B-557617

DIALS: 22C, 25F, 25G

COMMON SWITCH

WESTERN ELECTRIC COMPANY, INC.
ENGINEER OF MANUFACTURE
BELL TELEPHONE LABORATORIES
INCORPORATED

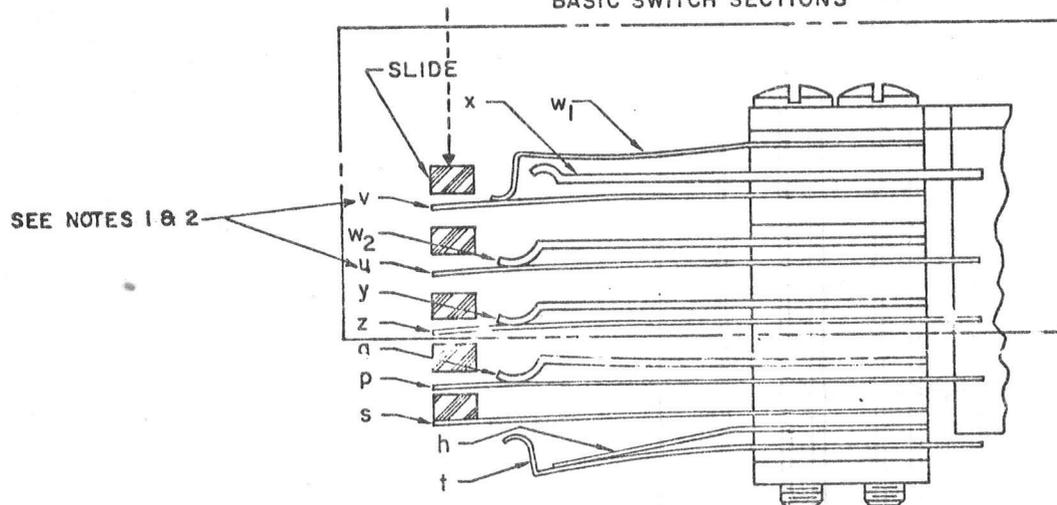
1. THE U & V CONTACTS ON 22C DIAL ARE REVERSED FROM THOSE SHOWN.
2. ON SOME 25F & 25G DIALS MANUFACTURED PRIOR TO MARCH 1964, THE U & V CONTACTS ARE REVERSED FROM THOSE SHOWN.
3. DOES NOT APPLY TO 25F, AND 25G DIALS MANUFACTURED AFTER 6-1-66.
- ~~4. ON 22B, 25A, 25B, 25E, & 25H DIALS MANUFACTURED PRIOR TO MARCH 1964 WHICH HAVE NOT BEEN MODIFIED IN ACCORDANCE WITH BSRS-451.917, THE U & V CONTACTS ARE REVERSED FROM THOSE SHOWN.~~

2-17-64 ISSUE 2
CONTACT DESIGNATIONS U & V WERE SHOWN REVERSED. NOTES 1 & 2 ADDED. 25L, 25M, 27A, 33B, & 35M CODES ADDED IN TITLE.

1-19-65 ISSUE 3
REMOVED: REFERENCE TO REPAIR AND 27A DIAL IN TITLE AND 27A IN NOTE 1
ADDED: NOTES 3 & 4

REMOVED: NOTE 4 AND 22B, 25A, 25B, 25D, 25E, 25H, 25J, 25L, 25M, 35B, AND 35M FROM TITLE.
